GTR #13 (Phase 2)

Recommendations for Test Procedures Task Force 3 Status

March 2021

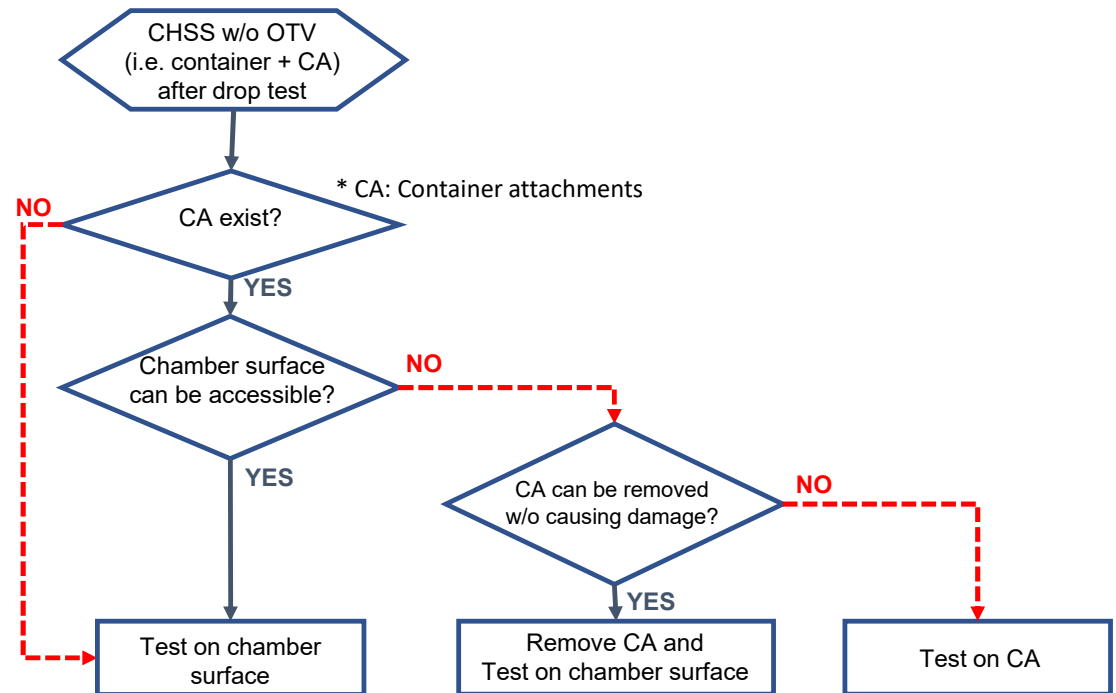
- **Revised 5.1**
 - 5.1 Compressed hydrogen storage system

This section specifies the requirements for a compressed hydrogen storage system (CHSS):

(a) The primary closure devices shall include the following functions, which may be combined:

- (i) TPRD;
- (ii) Check valve; and
- (iii) Automatic Shut-off valve

(c) Temporary removal and reinstallation of container attachments shall require the use of tools

(e) The CHSS shall meet the performance test requirements summarized in Table 1. The corresponding test procedures are specified in paragraph 6

- **New Figure 6**

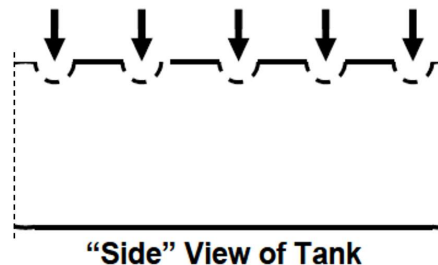
- **New description for “Surface damage test (unpressurized)”**

The surface damage tests and the chemical exposure tests (para. 6.2.3.4.) shall be conducted on the surface of the pressure bearing chamber of the container as long as it is accessible regardless of the existence of the container attachments.

If the container attachments can be removed in accordance with the process specified by the manufacturer, then the container attachments shall be removed and the tests shall be conducted on the surface of the pressure bearing chamber of the container.

Otherwise, the tests shall be conducted on the surface of the container attachments as indicated in the flow diagram.

The test proceeds in the following sequence:

(a) Surface flaw generation: A saw cut at least 0.75mm deep and 200mm long is made on the surface specified above.

If the container is to be affixed by compressing its composite surface then a second cut at least 1.25 mm deep and 25 mm long is applied at the location of this mounting interface.

(b) Pendulum impacts: A surface of the container opposite to the surface specified above or a surface of a different chamber, in the case of a multiple permanently interconnected chambers container, is divided into five distinct (not overlapping) areas 100 mm in diameter each (see Figure 6). Immediately following a minimum of 12 hours preconditioning at ≤ 40 °C in an environmental chamber, the centre of each of the five areas sustains the impact of a pendulum having a pyramid with equilateral faces and square base, the summit and edges being rounded to a radius of 3 mm. The centre of impact of the pendulum coincides with the centre of gravity of the pyramid. The energy of the pendulum at the moment of impact with each of the five marked areas on the container is 30 J. The container is secured in place during pendulum impacts and not under pressure.
